SUBJECT: Improve Dimmer Function of Panel Lights

MODELS/ SN M20U Ovation Ultra - 32-0002

AFFECTED: M20V Acclaim Ultra - 33-0002, 33-0003, 33-0005

Figure SB M20-330-1 – Rewire Headliner #2

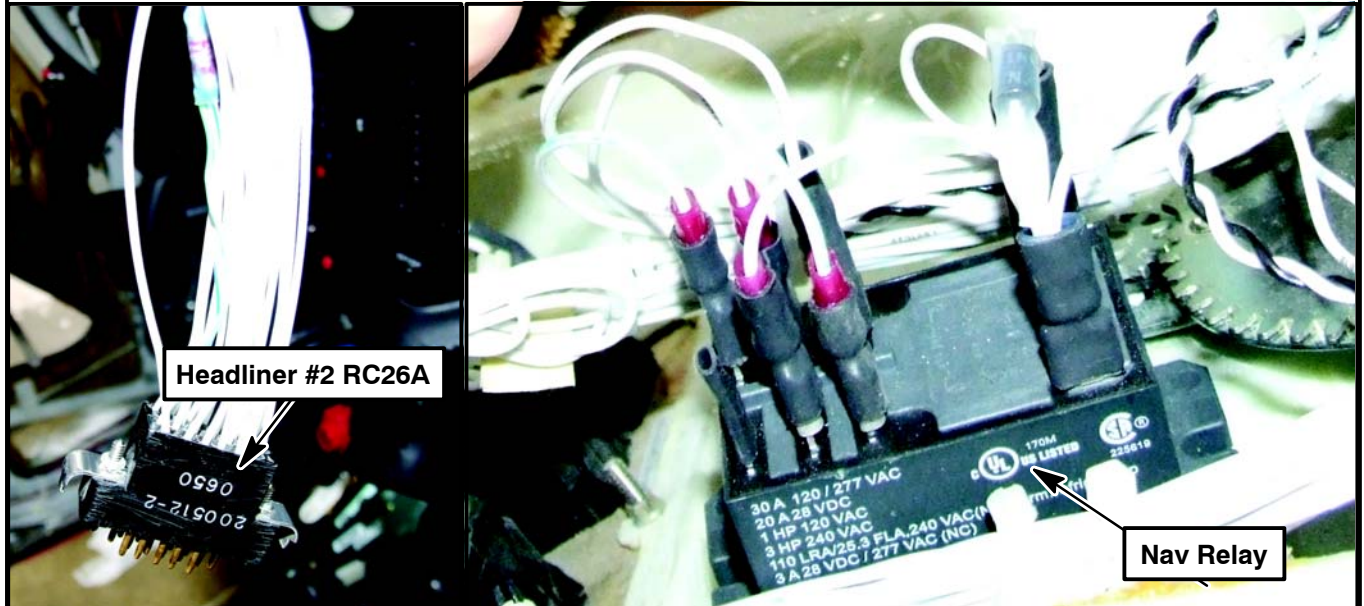
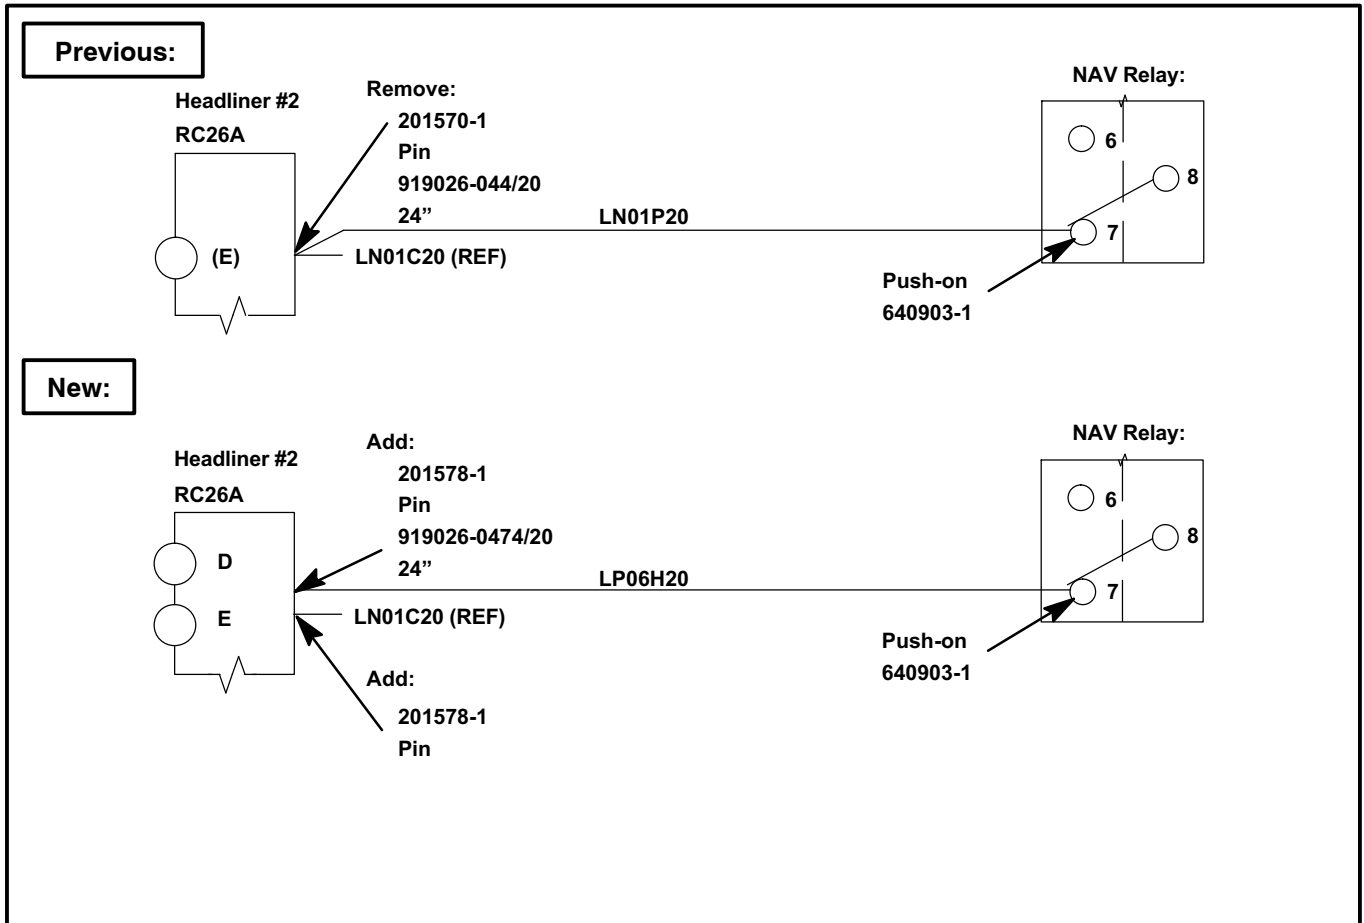
- 1.3. Above the PSU panel on the PSU wire harness, locate and disconnect the Headliner #2 PL/RC26A connectors. De-pin the LN01P20 and LN01C20 wires from pin E of the PSU Headliner #2 connector. Disconnect LN01P20 push-on terminal from the NAV Light Relay terminal #7. Remove and discard the 201570-1 pin that was de-pinned from pin E and the LN01P20 wire segment. See Figure SB M20-330-1.

- 1.4. Terminate a new 201578-1 pin onto the existing LN01C20 wire and reinsert the wire back into pin E of the PSU Headliner #2 connector. See Figure SB M20-330-1.

- 1.5. Terminate the 640903-1 push-on terminal onto the new LP06H20 36" 919026-044/20 wire segment and connect the terminal to the NAV Relay terminal #7 where the previous wire segment was removed. Route and secure the wire along the existing PSU harness to the Headliner #2 connector. Trim wire length as required, terminate a new 201578-1 pin onto this wire, and insert wire into pin D of the connector. See Figure SB M20-330-1.

Figure SB M20-330-2 – Route Additional Wire from Dimmer Control Plug 6 to Headliner #2

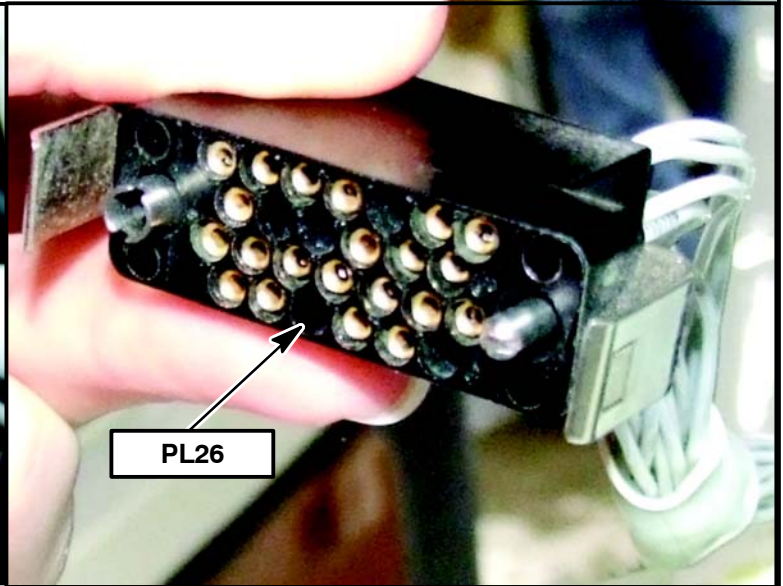
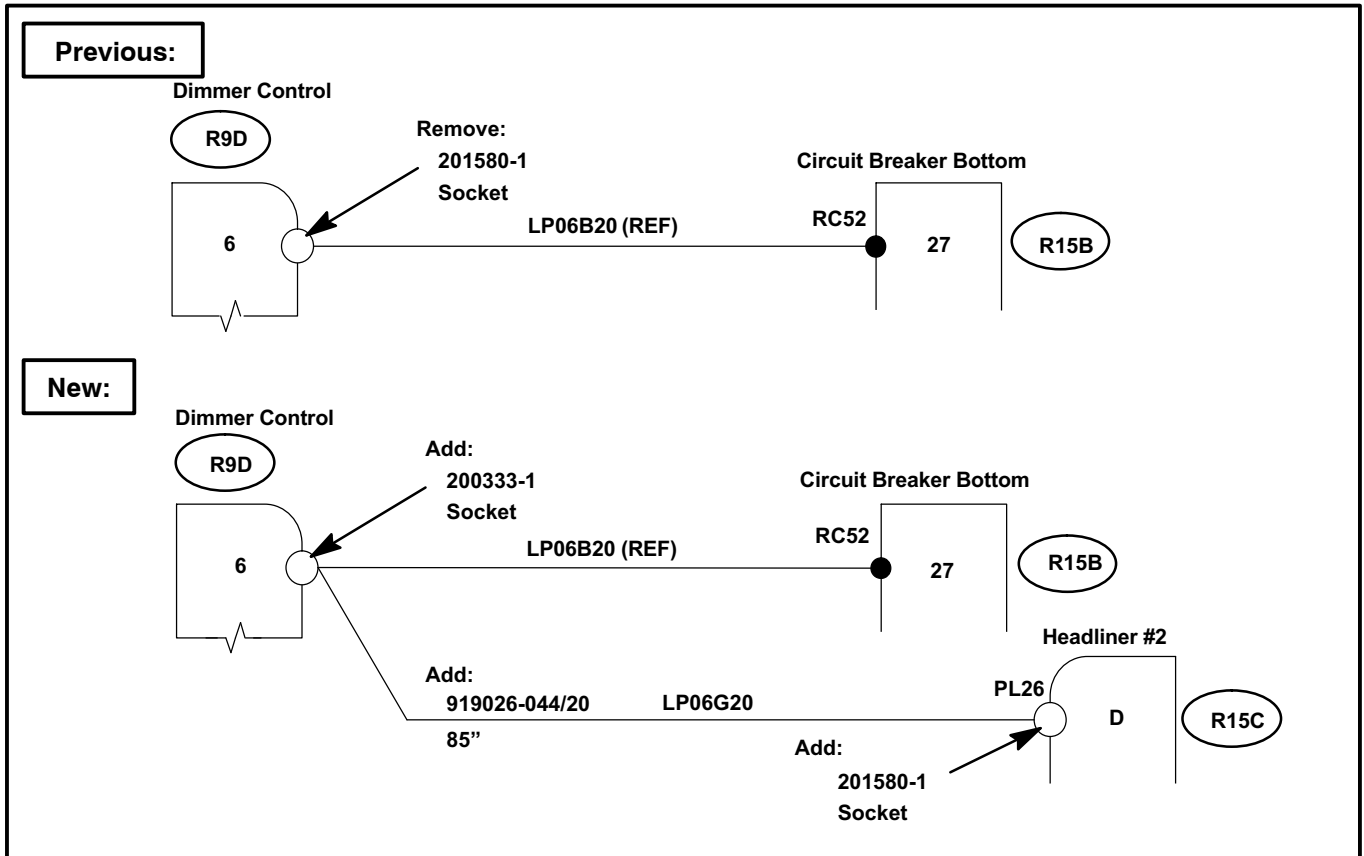
- 1.6. Locate and disconnect the Dimmer Control plug located under the right side of the instrument panel. De-pin pin 6 from the connector and remove the 201580-1 socket from the LP06B20 wire segment. See Figure SB M20-330-2.

- 1.7. Terminate a new 201580-1 socket onto the new LP06G20 97" 919026-044/20 wire segment and insert into pin D on the aircraft side of the Headliner #2 connector. Route and secure the wire following the existing harness down the right-hand forward pillar to the Dimmer Control connector. See Figure SB M20-330-2.

- 1.8. Trim wire length as required and terminate a 201333-1 socket, combining the existing LP06B20 and new LP06G20 wire segments at the Dimmer Control connector. Insert the new socket back into pin 6 where the LP06B20 wire was previously de-pinned. See Figure SB M20-330-2.
- 1.9. Perform a point-to-point continuity check of the newly installed wire segments. If check shows as good, reconnect and re-secure Headliner #2 and Dimmer Control connectors. If check shows as bad, verify and troubleshoot until corrected. See Figure SB M20-330-2.
- 1.10. Reinstall previously removed interior components from step 1.2 in reverse order and return aircraft to service.
